**REMEDIATION SYSTEM EVALUATION**

**SOUTH TACOMA CHANNEL/WELL 12A  
SUPERFUND SITE  
TACOMA, WASHINGTON**

Report of the Remediation System Evaluation,  
Site Visit Conducted at the  
Commencement Bay/South Tacoma Channel Well 12A Superfund Site  
August 21-22, 2001

Final Report Submitted to Region 10  
December 10, 2001

**FIGURE 1-2. LAYOUT OF THE TIME OIL PROPERTY INDICATING THE LOCATIONS OF THE GROUNDWATER EXTRACTION WELLS AS WELL AS AREAS OF CONTAMINATED SOIL, DNAPL, AND FILTER CAKE**

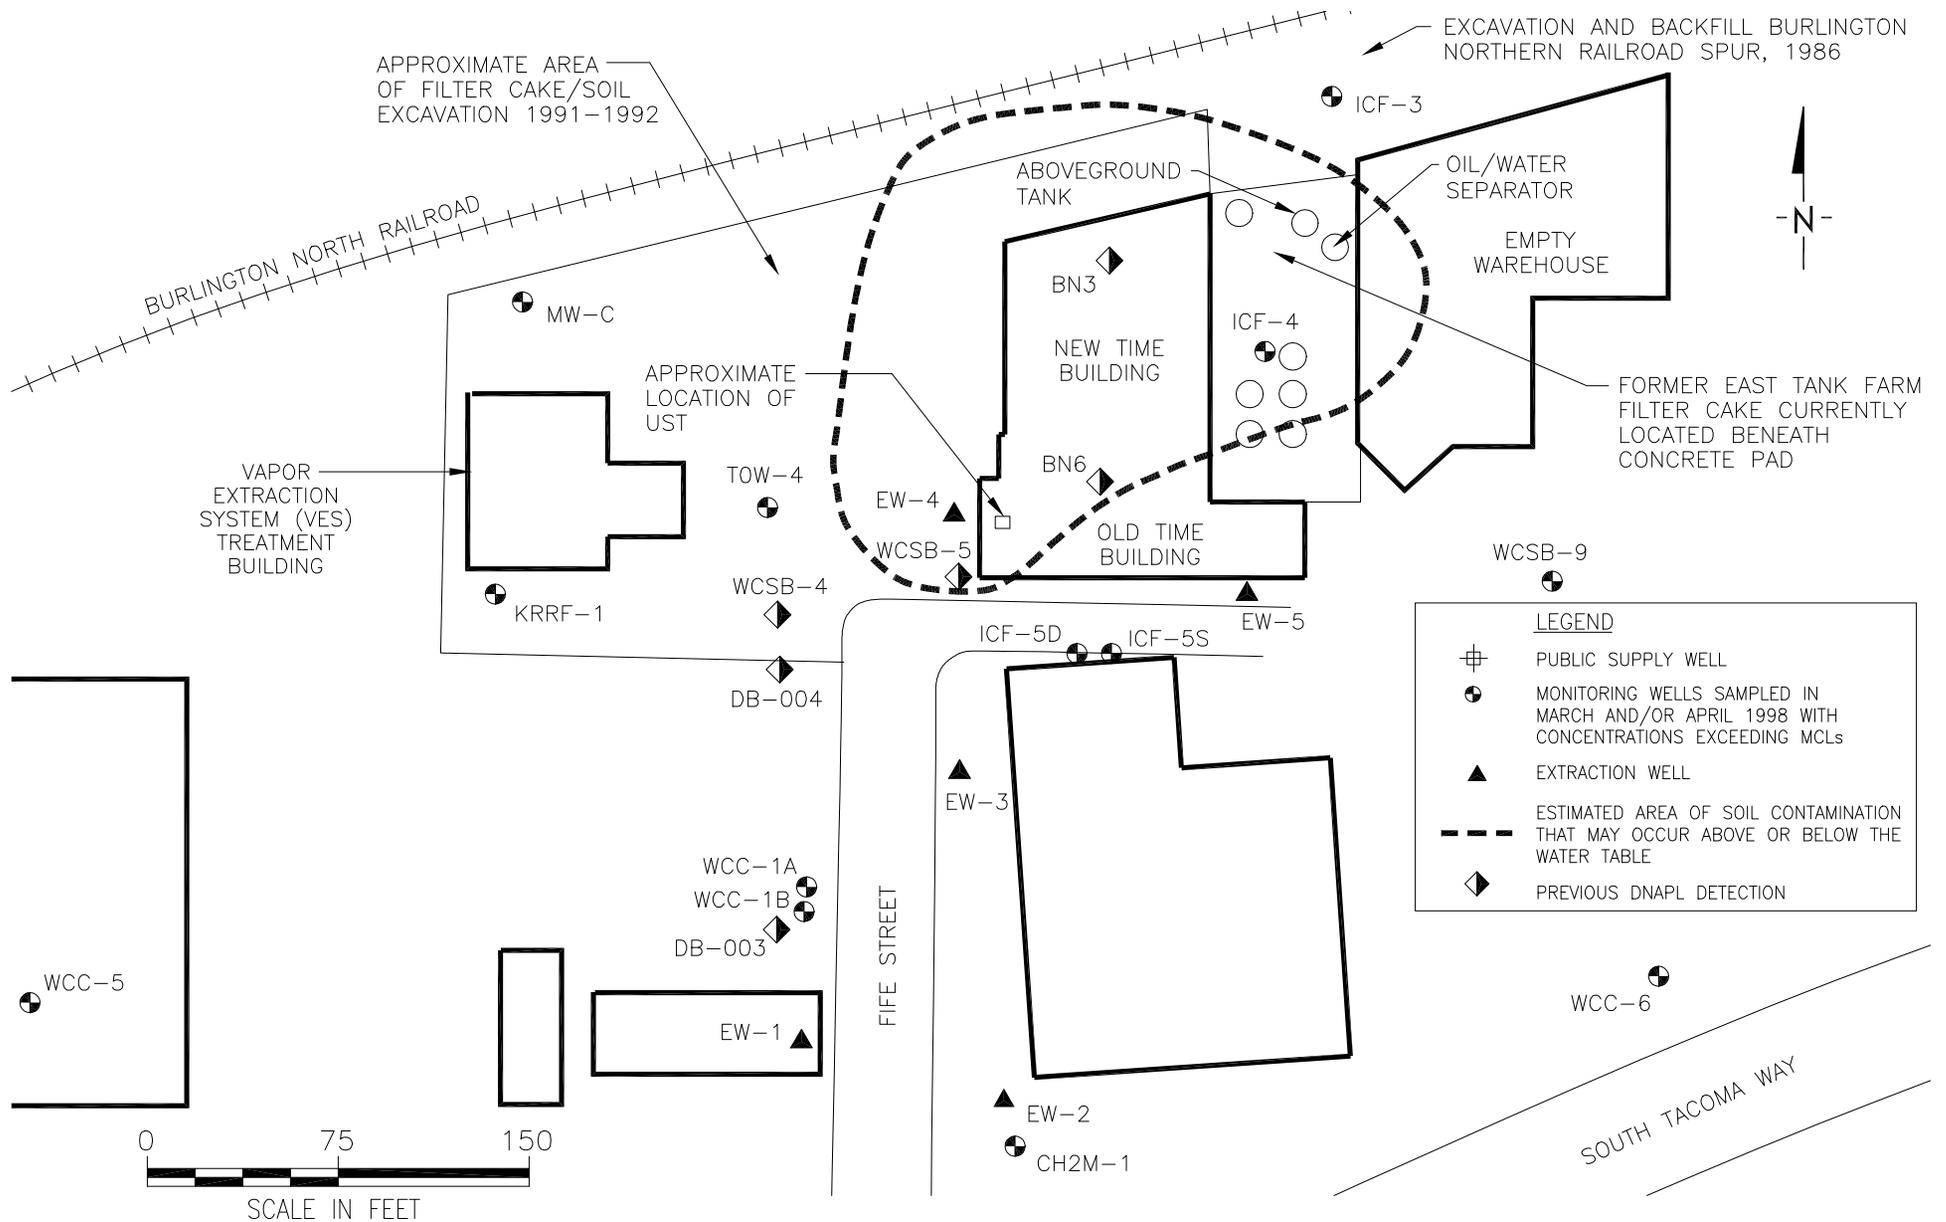
The locations of all extraction wells are indicated on Figure 1-2.

The pumps in EW-2, EW-3, and EW-4 are oversized for the yields of these wells. EW-2 and EW-4 have 7.5 horsepower pumps and EW-3 has a 10 horsepower pump. These pumps each push approximately 10 gpm of water against approximately 115 feet of head— 35 feet from the water table to the ground surface, approximately 20 feet to the top of the GETS, and across 60 feet of pressure drop (over 25 psi) through the GETS. Movement of water with a pump efficiency of 50% would require approximately 0.6 horsepower. Using a 1.5 horsepower pump would easily accommodate this current load and could provide additional flow if necessary. Thus, converting from the current pumps to 1.5 horsepower pumps as currently used in EW-5 would save over 20 horsepower. Assuming approximately \$0.05 per kilowatt hour, a savings of approximately \$700 would be realized each month (approximately \$8,500 per year). Installing the three new pumps would likely cost approximately \$14,000. Thus, if the current GETS is selected as the final remedy or as an interim remedy for three or more years, it would be cost-effective to replace the pumps as suggested.
